CASE SUMMARY SHEET

CASE NUMBER: V23-04-12

REQUEST: V23-04-12 – Allison and Brian Froeba request a variance to CLURO Section 9.2.5.2. Vegetation Protection Zones, Square 5 Lot 6A, R-1 Single Family Residential District, 1617 Lakeshore Drive

To: Cara Bartholomew
From: Catherine Fuselier
Date: April 11, 2023
Subject: V23-04-12

A PROPOSED DRAINAGE PLAN FOR A PORTION OF SQUARE 77, TOWN OF MANDEVILLE, ST. TAMMANY PARISH, LOUISIANA

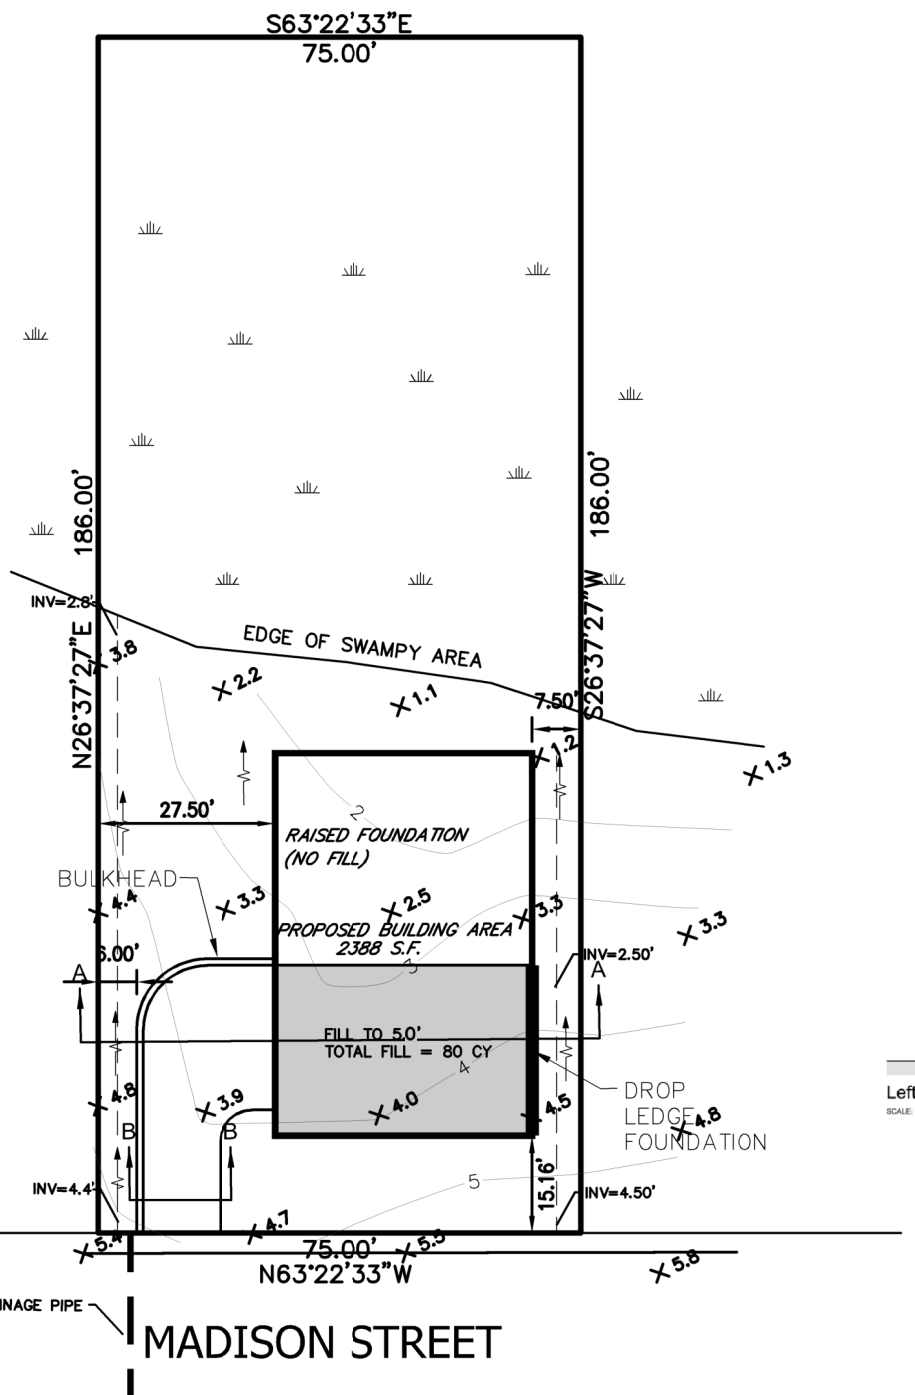
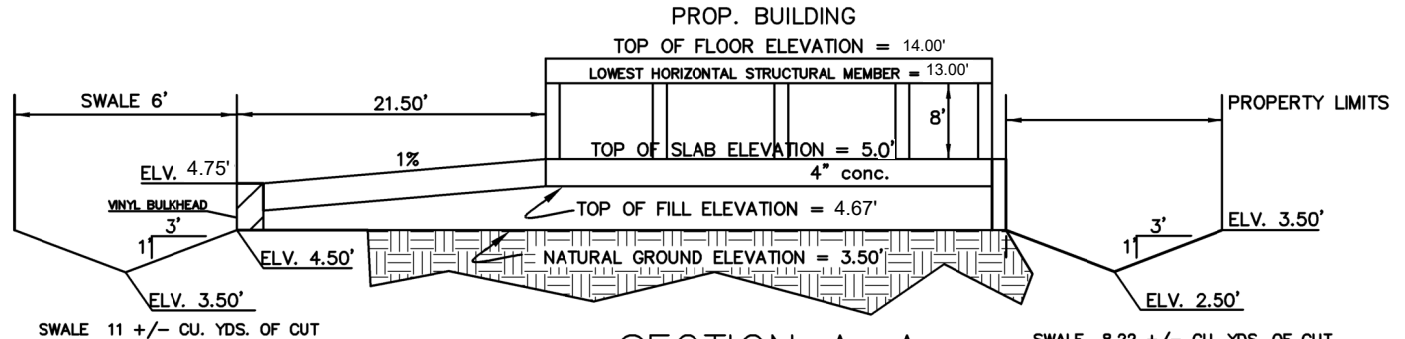
The applicant is requesting to add additional fill under the front portion of the home. The lot has a steep slope downward, with the rear of the lot measuring 1.1' msl and the front of the lot is 4.9' msl. The additional fill in the front of the home would bring the height up to 5' msl. This would be an increase of 1' – 2' of additional fill as shown on the drainage plan prepared by J.V. Burkes & Associates, Inc. and dated 6.23.21. The additional fill will help combat the issue of swaying which has occurred per a letter from Warren L. Dietz Jr., P.E. and dated 2.21.23.

A retaining wall is being proposed along the rear edge of the area to be filled. This is to prevent any fill from running off from the placement area. The wall will run along the outer edge of the driveway, across the rear boundary of the fill area, and along the eastern side of the proposed fill area before ending. The top of the wall will have an elevation of 6' and the wall will have drainage outlets on the rear (north) side.

The applicant is requesting a variance to CLURO section 5.2.3.2 to add an additional 1' – 2' of fill to reach an elevation of 5' msl, and to construct a retaining wall measuring 6' to encapsulate the fill and prevent any runoff.

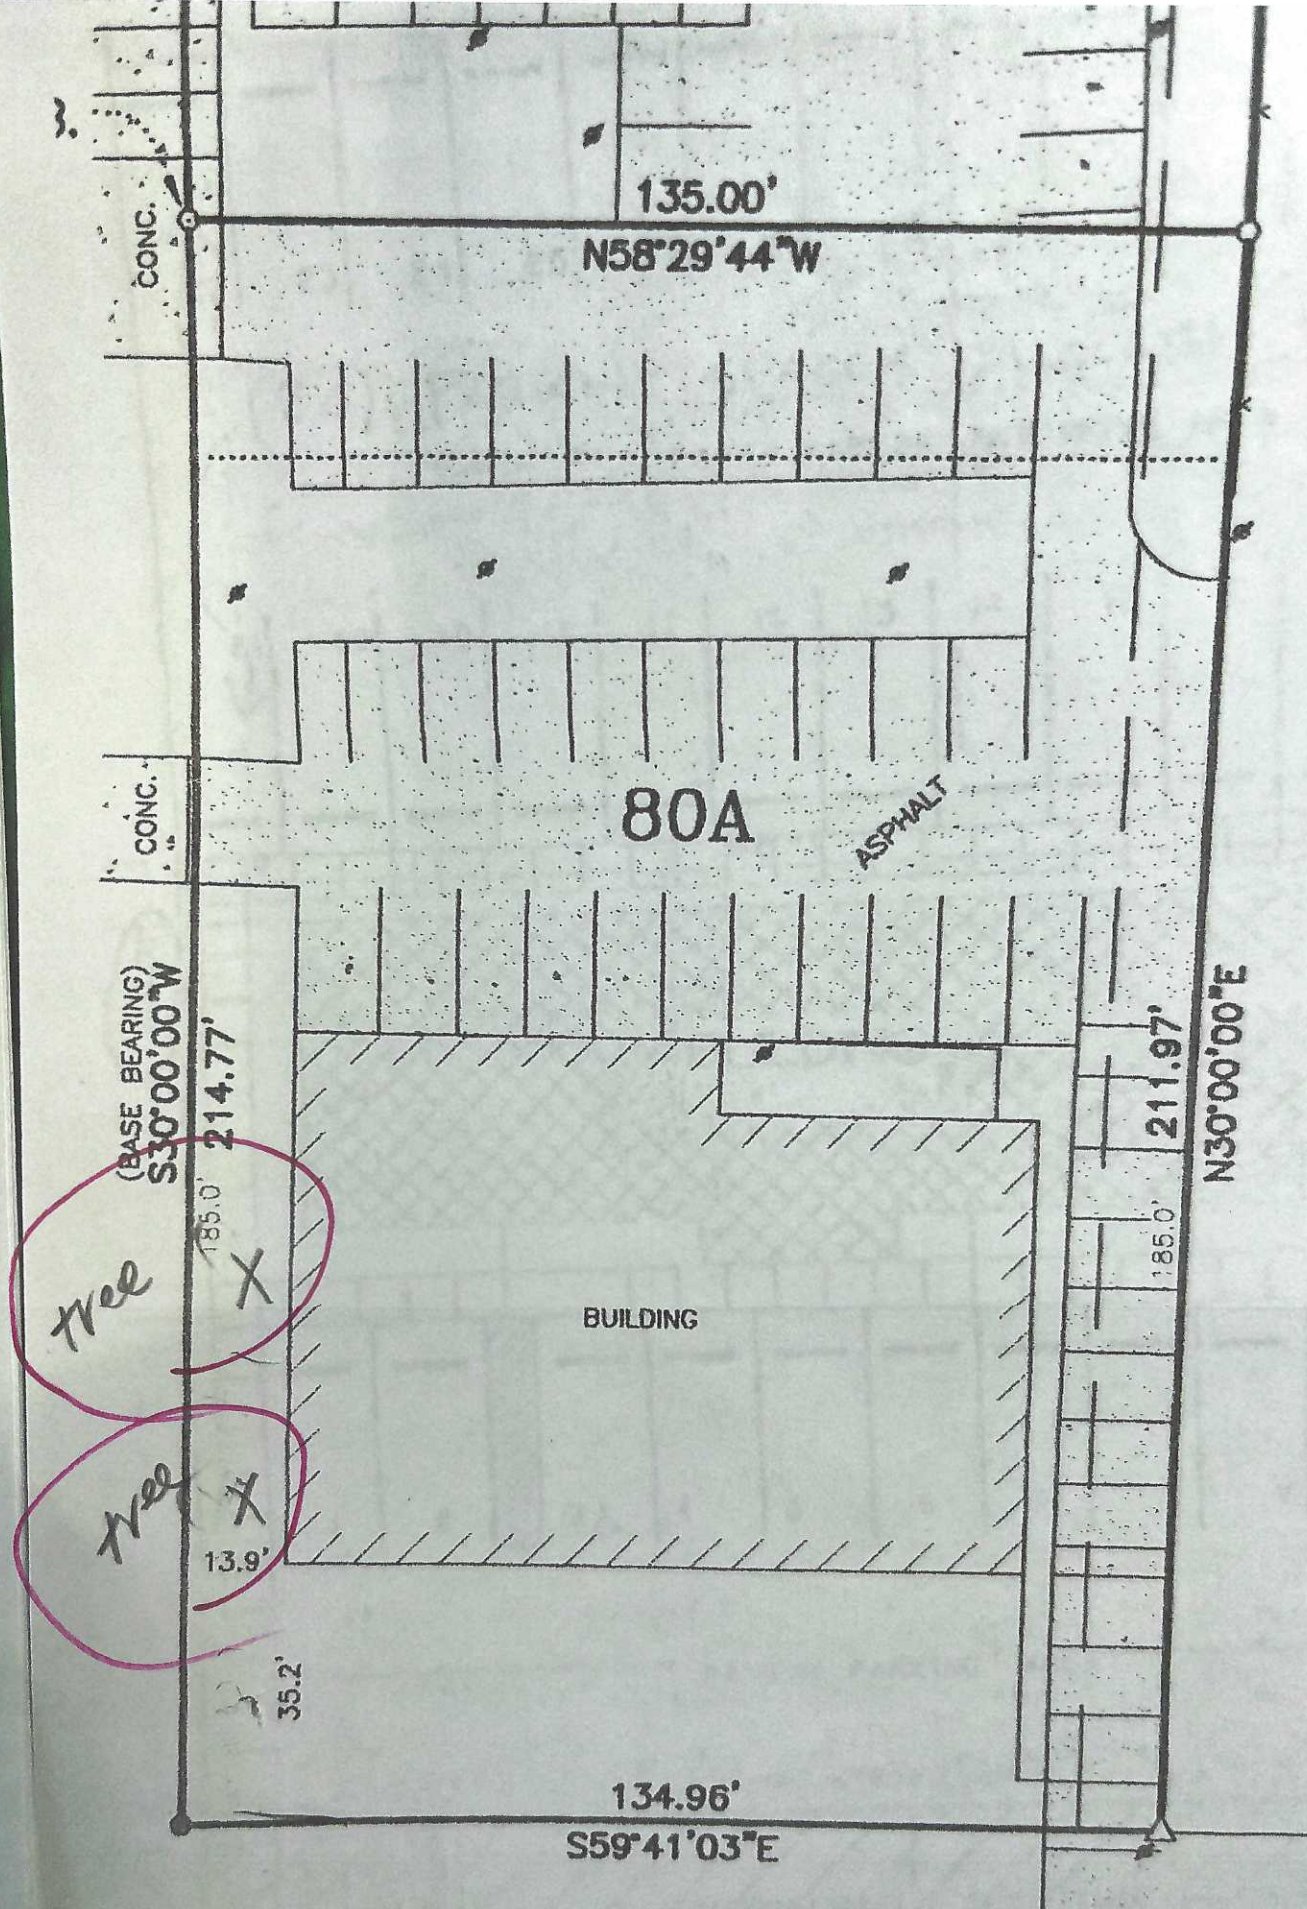
A site inspection was performed to inspect the health of the two live oaks on the property and to evaluate the need for removal. The inspection found two live oak trees located within the Park Ave Greenbelt and measured 19" and 25" in DBH. The 25" live oak was found to be closest to the building and has a few branches growing over the building and has surface roots around the base of the tree up to the concrete walkway around the building. The 19" DBH live oak was found to be located closer to the street and with no visible surface roots or branches growing over the building. Both trees were found to be healthy and in good condition. The insurance note states that the trees should be cut back to reduce the potential for damage to the building but did not go into the extent that should be pruned to achieve this so it is not possible to know if the amount of pruning required would cause negative impacts to the tree or not. A meeting should be set for the insurance inspector to determine what work would be needed to allow continued insurance. Additionally, the arborist report referenced the trees roots causing damage to the structure, this would be extremely unlikely as generally roots do not grow under foundations. The majority of tree roots grow in the top 12" of soil and when the hit a

buildings foundation they generally turn and grow along, not under. More often than not if there is issue with the foundations it would be from the soil not a tree root. Based on the submitted documentation it does not appear that the removal of these two healthy live oaks will enhance the health, safety, and welfare of the public, or otherwise benefit the public interest. If the two trees are approved to be removed, they would require 7 2” caliper live oak replacement trees.
